ONSITE SEWAGE DISPOSAL SYSTEM

PERMIT

MINOR REPAIR

PROPERTY ADDRESS: 13001 Wainright Road

13001
Wainwright
Road

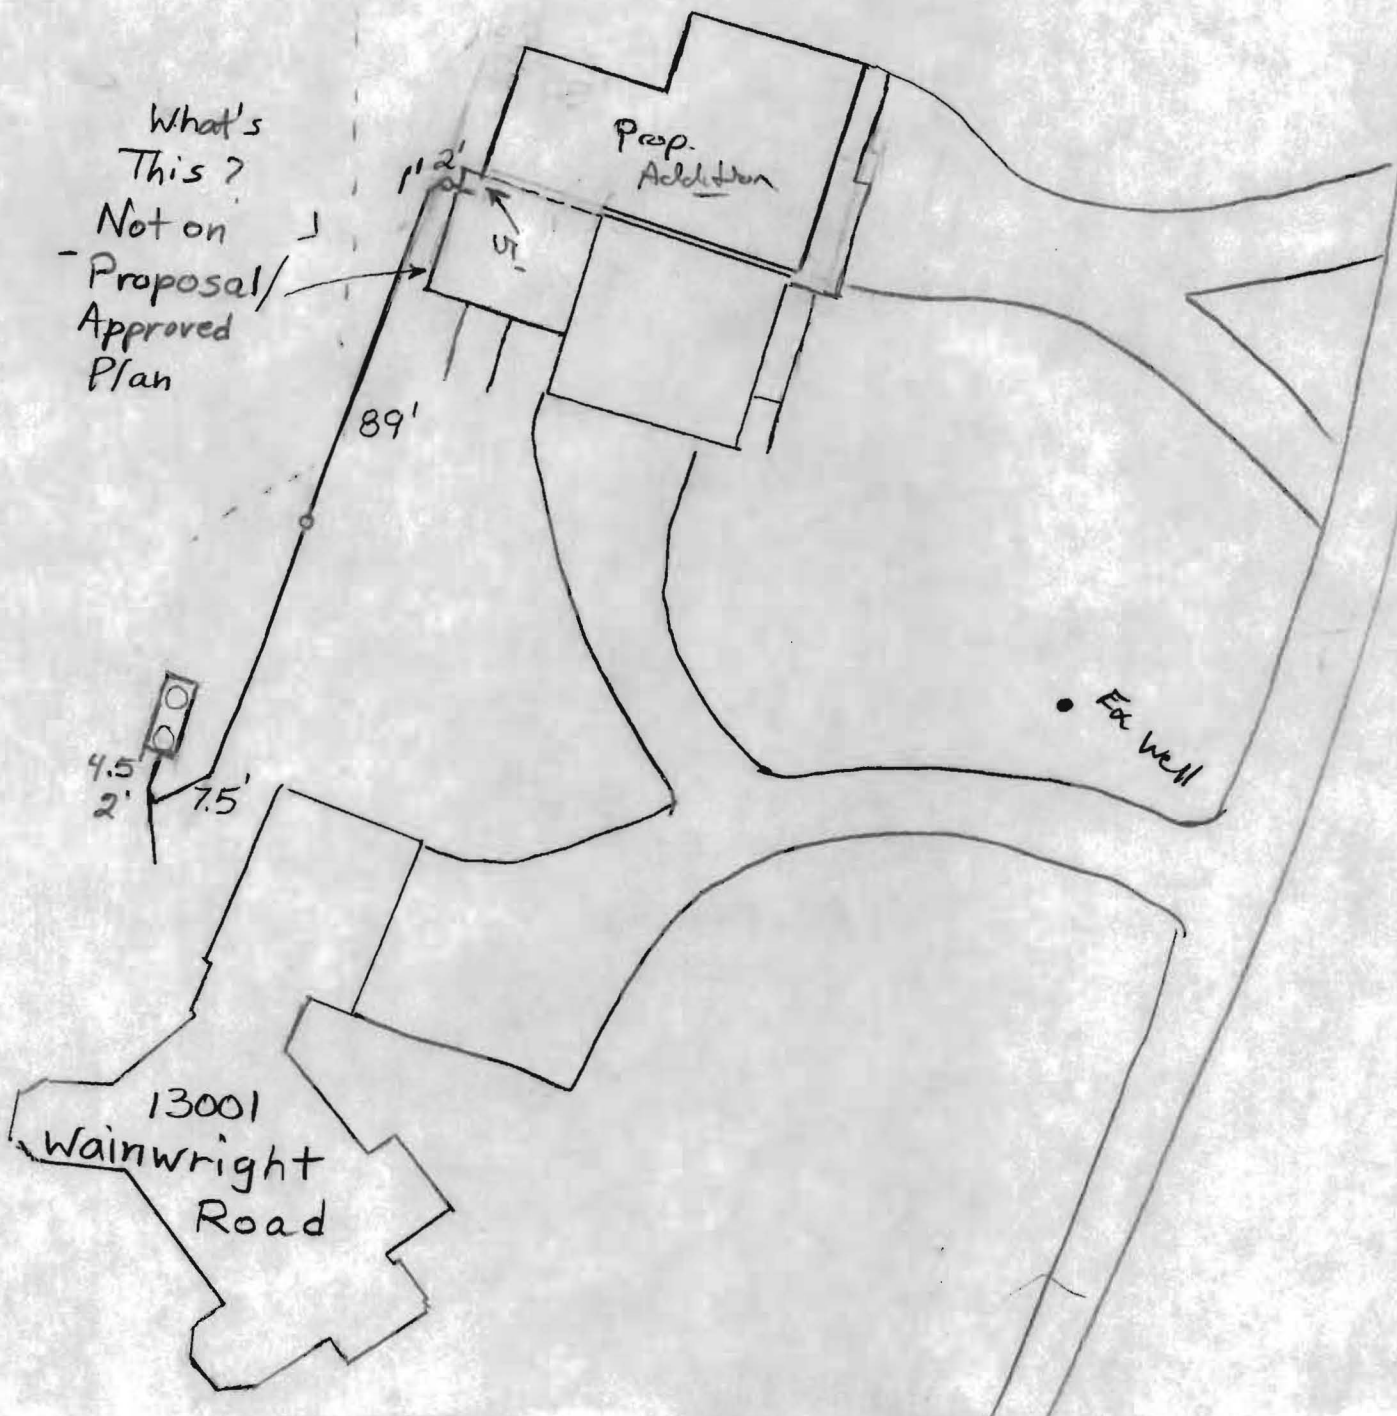
INSTALLATION: 12/8/2014 Connection made from new building to existing septic system. Building footprint does not match approved plan. (BB)

What's
This?
Not on
- Proposal/
Approved
Plan

PARCEL 398
 REVISED PARCEL TWO
 6.0 ACRES±

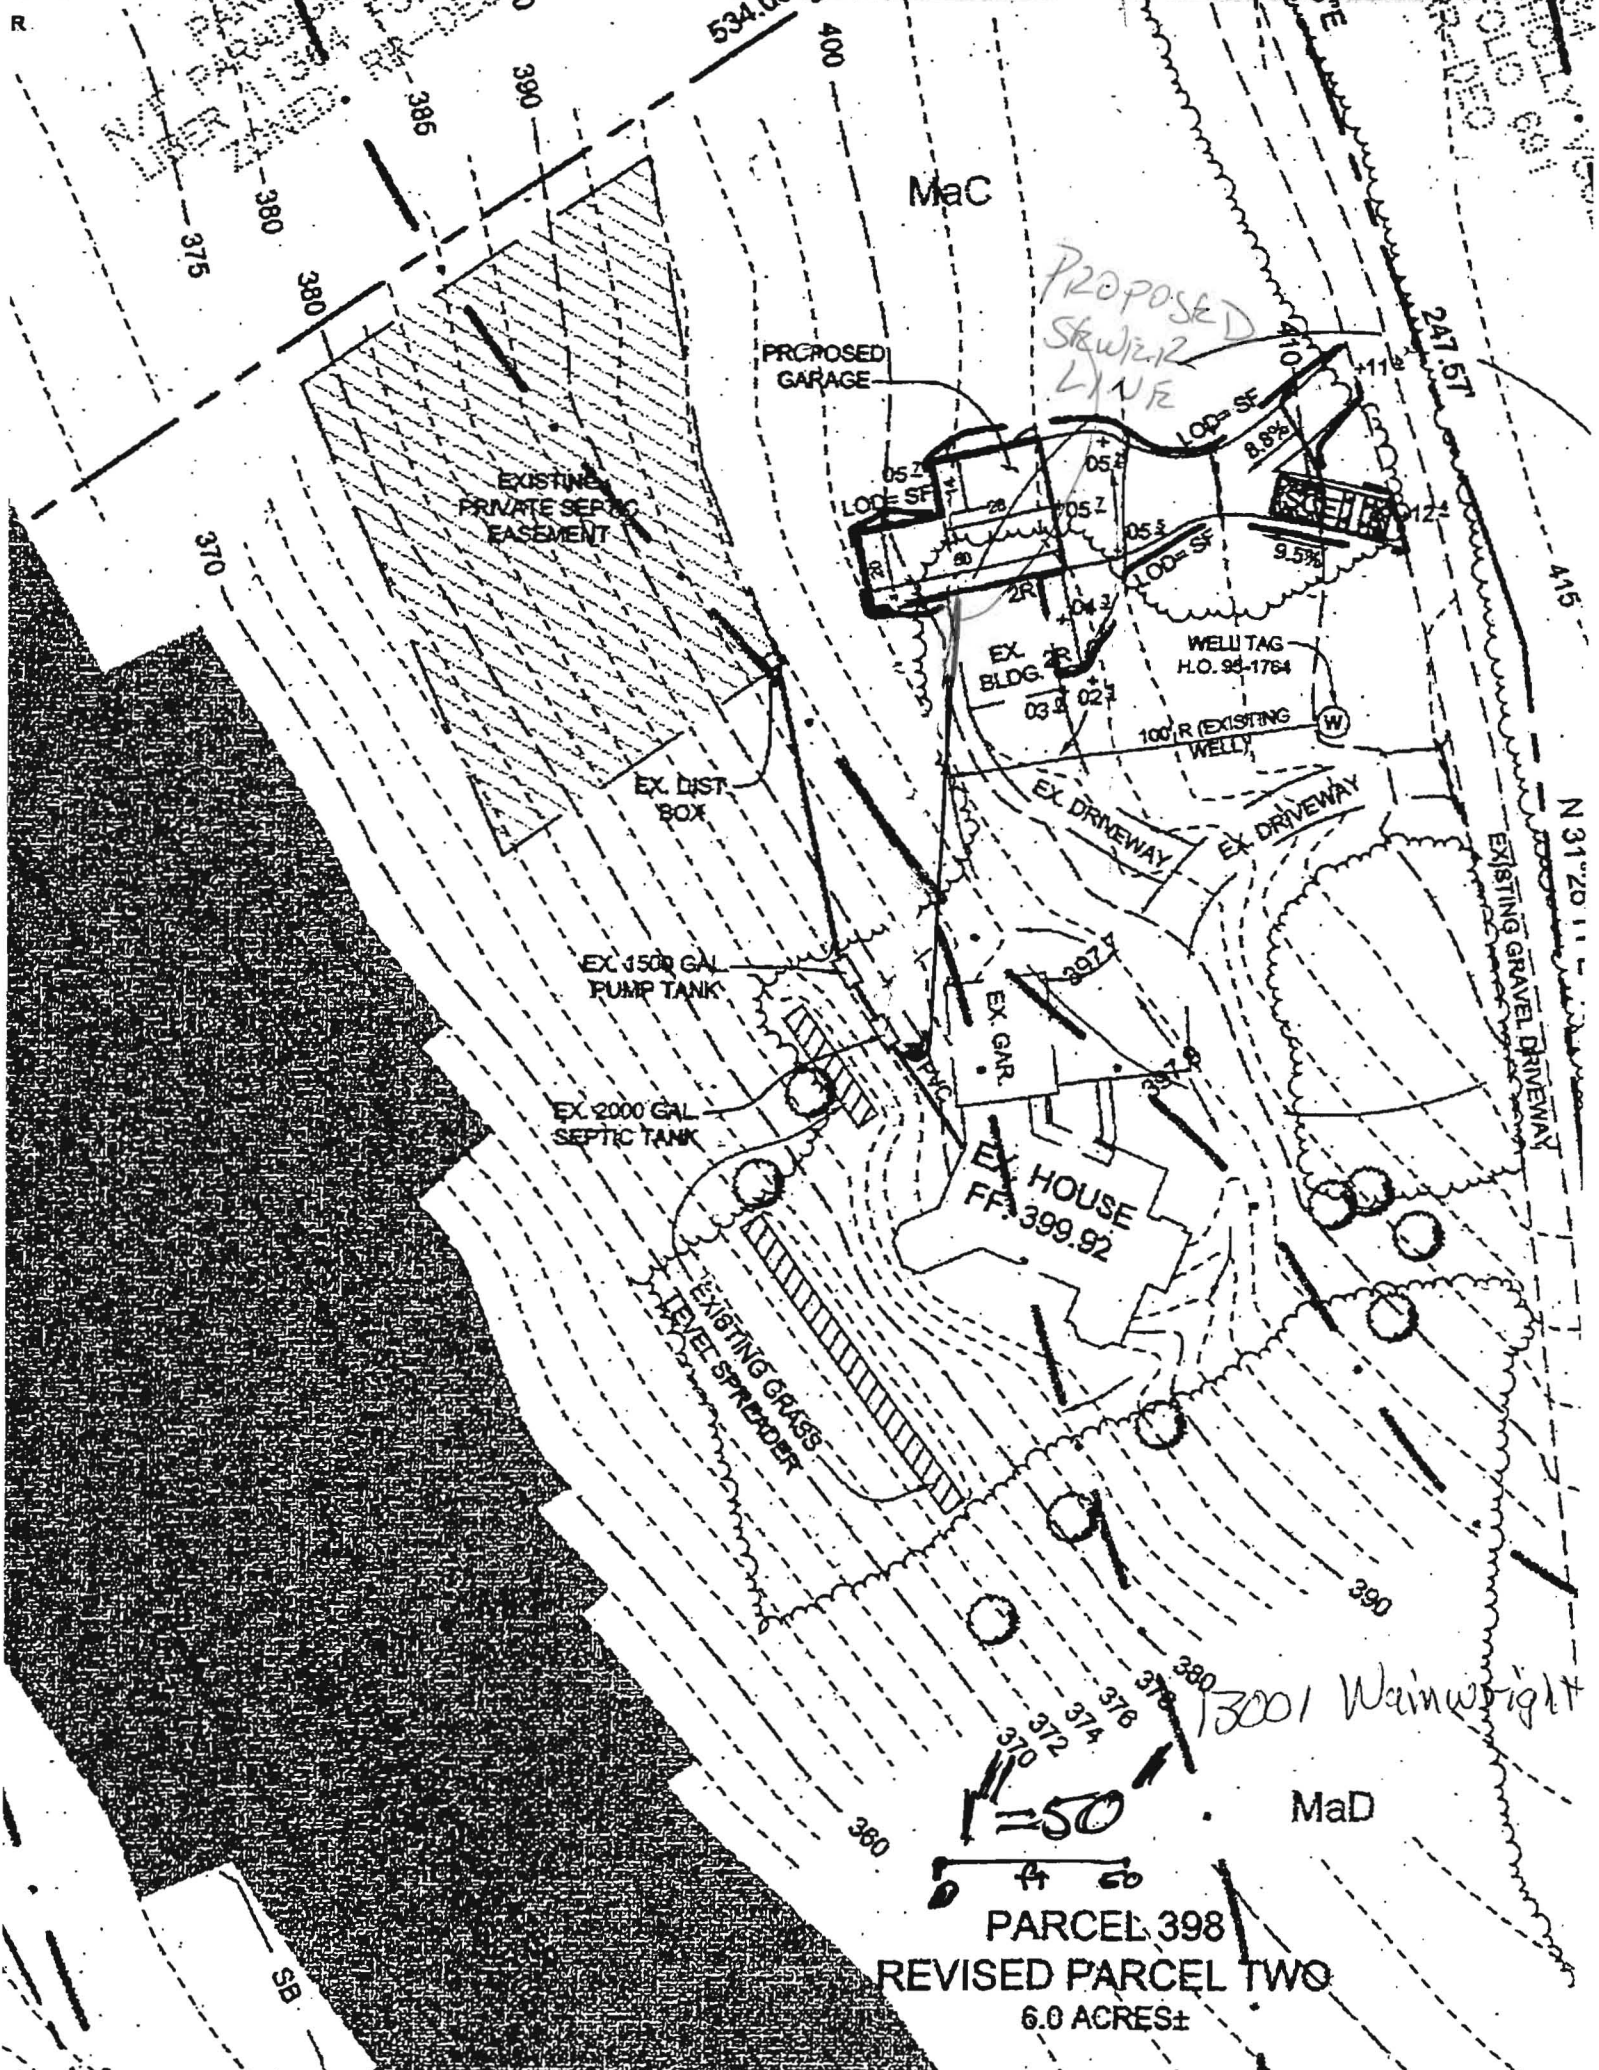
- Install ~~SHE~~ 4" PVC from garage to SHE before Septic Tank.
- Use 'WYE' ^{for} connection in house SHE.
- Install cleanouts every 70' from garage foundation, and at 'WYE' connection.
- Call for inspection one day in advance
- Do not cover work until Environmental Sanitarian has inspected installation.
